KAV60 Schematics Document

Intel Diamondville Processor with Calistoga(945GSE) + DDRII + ICH7M

REV: 1.0

Version change list (P.I.R. List)

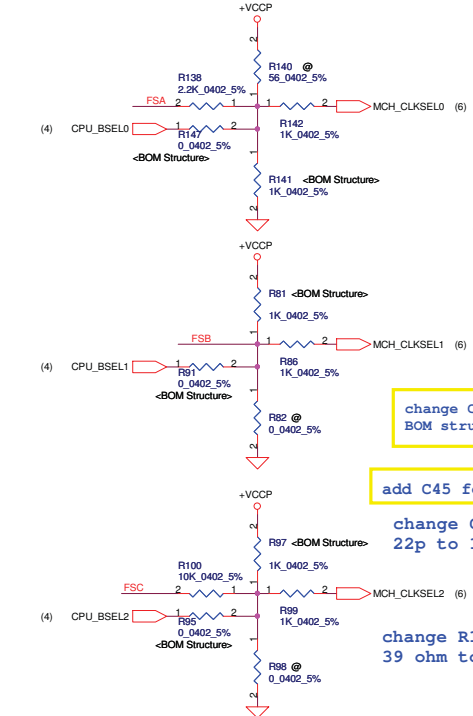
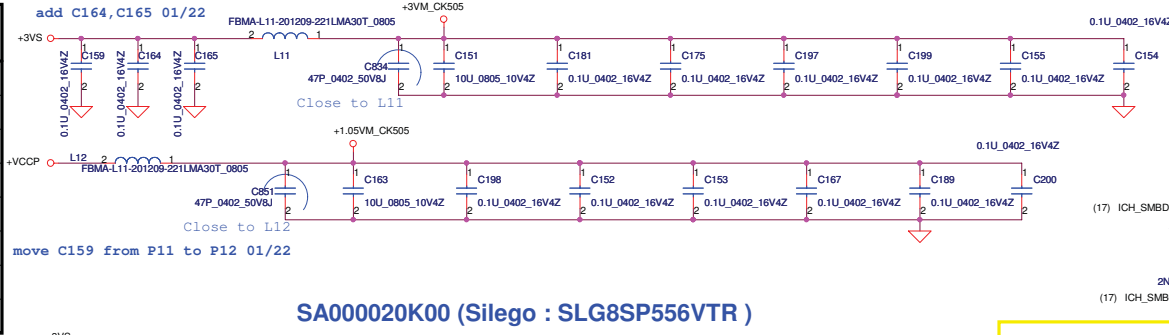
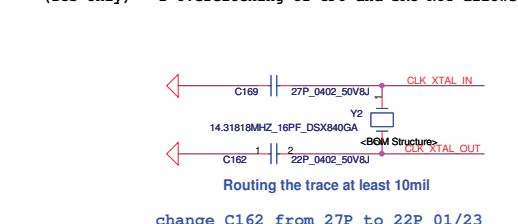
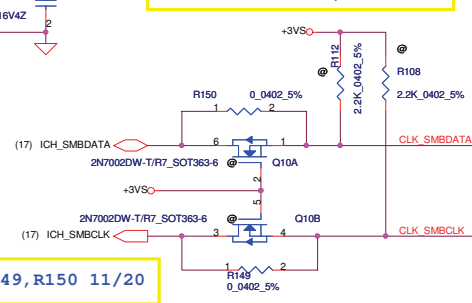
change R141,R140,R147,R81,R91
R82,R97,R95,R98 BOM structure 12/29
change R141,R140,R147,R81,R91
R82,R97,R95,R98 BOM structure 01/17

add R149, R150 11/20

change R112,R108,Q10A,Q10B
BOM structure 11/20

Int. Speaker Conn.

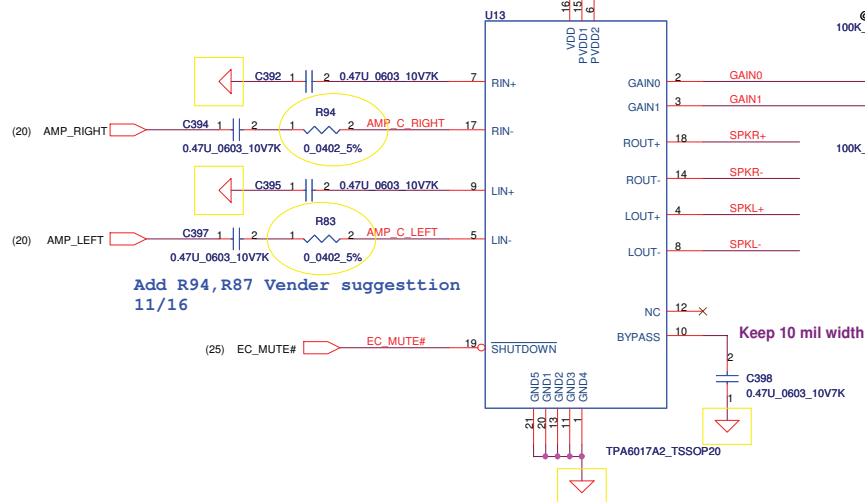
Add R94,R87 Vender suggestion 11/16

change +5VAMP to +5VS 12/02

change JP20 Conn and pin design 11/26

del R388,R387,R386,R385,D10,D13 12/11

change JP20 Conn 01/16

SWAP JP20 01/20

20081029 Update to 6dB

Analog ground change to digital ground 08/11/16

SATA&CARDREADER&USB Conn

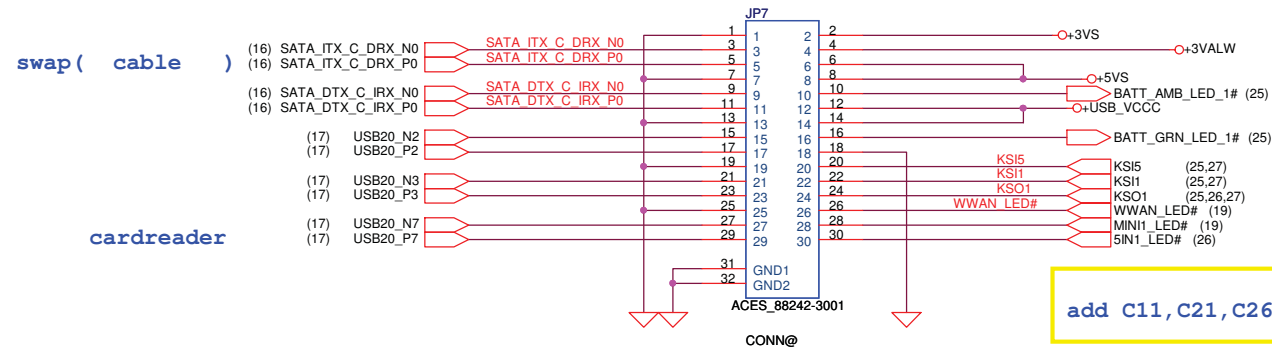
Move SATA HDD Conn to small board 11/21

SWAP JP7 pin define 12/03

+3VS_READER change to +3VALW 12/15

add net name BATT_AMB_LED#
BATT_GRN_LED# 12/15

add J15 J16 12/08

del J15,J16,C21 12/15

add C11,C21,C26,C27 for keypart 12/08

add C28 for keypart 01/14

del C11,C28,C26 01/21

del C26 02/03

ADD SATA&CARDREADER&USB Conn(JP7) 11/26

ON/OFF switch

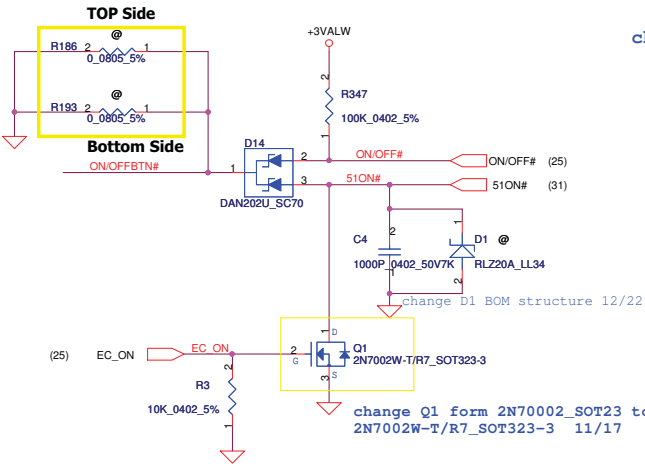
change J1,J3(43 x 79) to R186,R193(0_0805) 11/16

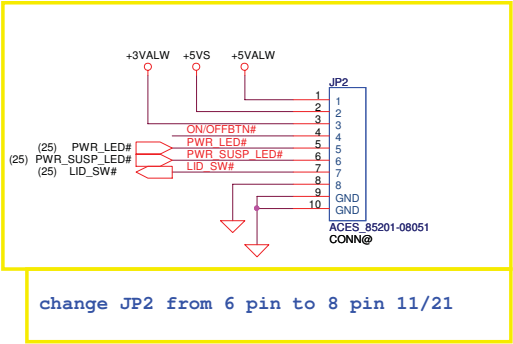
change JP2 Conn 12/01

change JP2 Conn 11/25 To PWR/B Conn.

Change PWR_LED and PWR_SUSP_LED Net name 01/13

change R518 from 300 to 422 ohm 02/06

INT_KBD Conn.

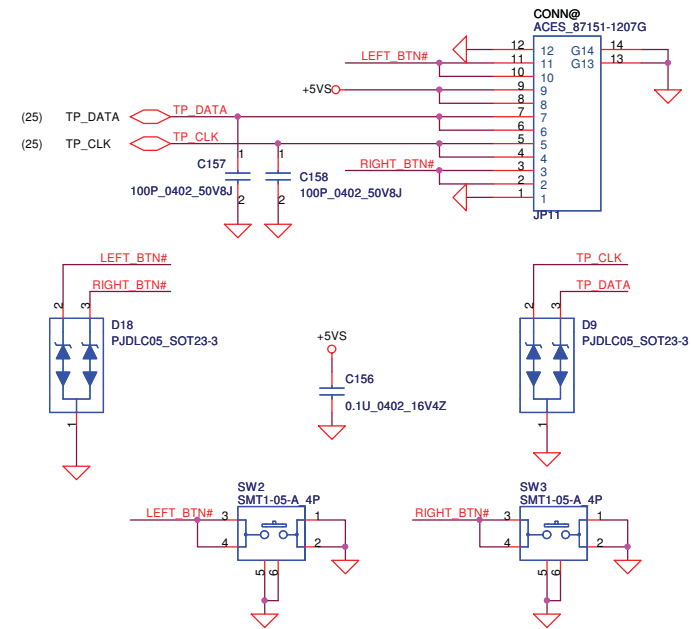
SWAP JP11 01/13

change D18 P/N from SC10T24C010 to SCA00000A00 and BOM structure 12/22

change D9 P/N from SC10T24C010 to SCA00000A00 and BOM structure 12/22

To SDIO Conn.

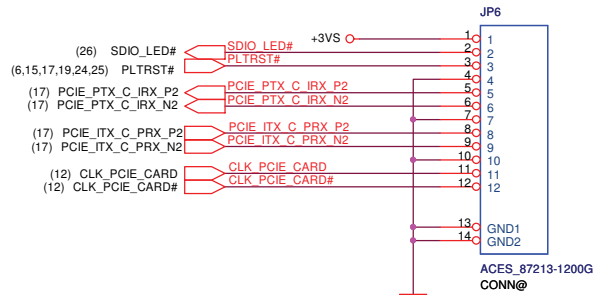
swap JP6 pin define 12/08

swap CLK_PCIE_CARD and CLK_PCIE_CARD# 12/16

USB CONN. 1

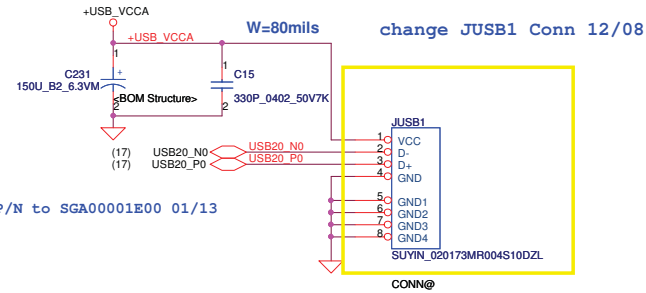
U3 Change to SA000035G00
12/31

Change U3 from SA000035G00
to SA000022J00 02/06

FAN1 Conn

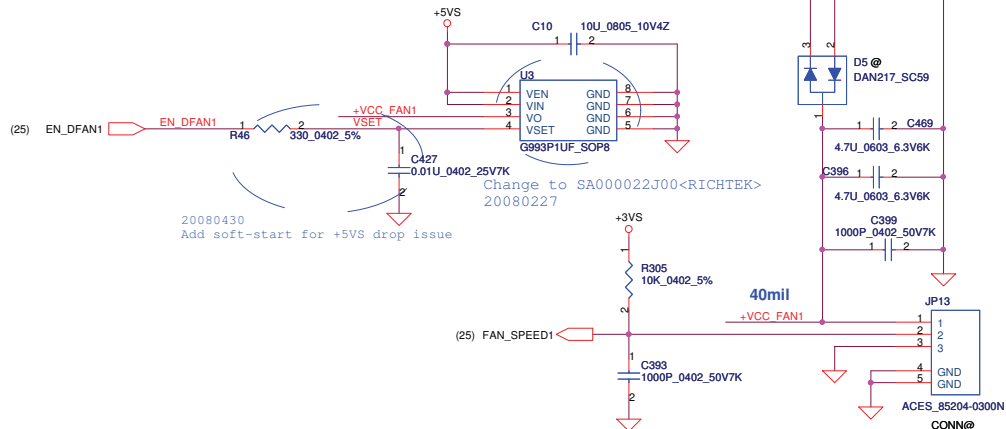
change C396 from 10U/0806 to 4.7U/0603 01/22
add C469 01/22

change D5 BOM
structure 01/23

del D8 and change
D5 P/N 12/05

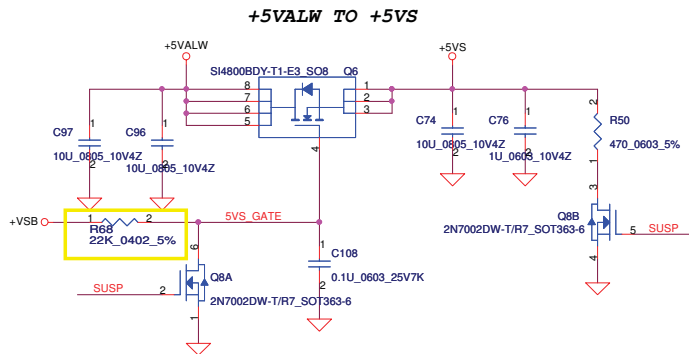
change R68 from 200K to 22K 12/10

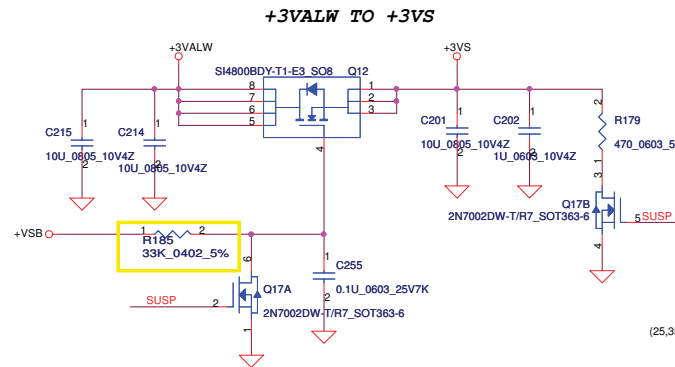
change R185 from 200K to 33K 12/10

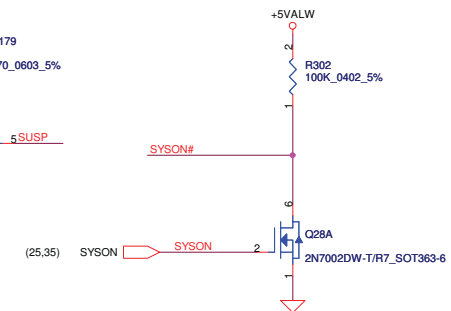
+5VALW CHANG TO VL
11/16

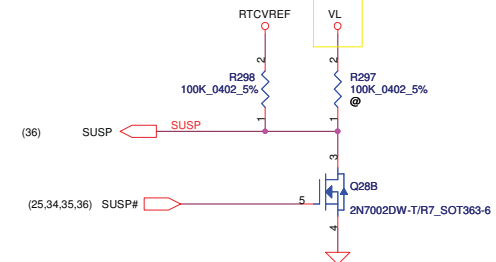
change Q2,Q15,Q24,Q7,Q23 form 2N70002_SOT23 to
2N7002W-T/R7_SOT323-3 11/17

change R18,R169,R280,R61,R279
Q2,Q15,Q24,Q7,Q7,Q23 BOM structure 11/16
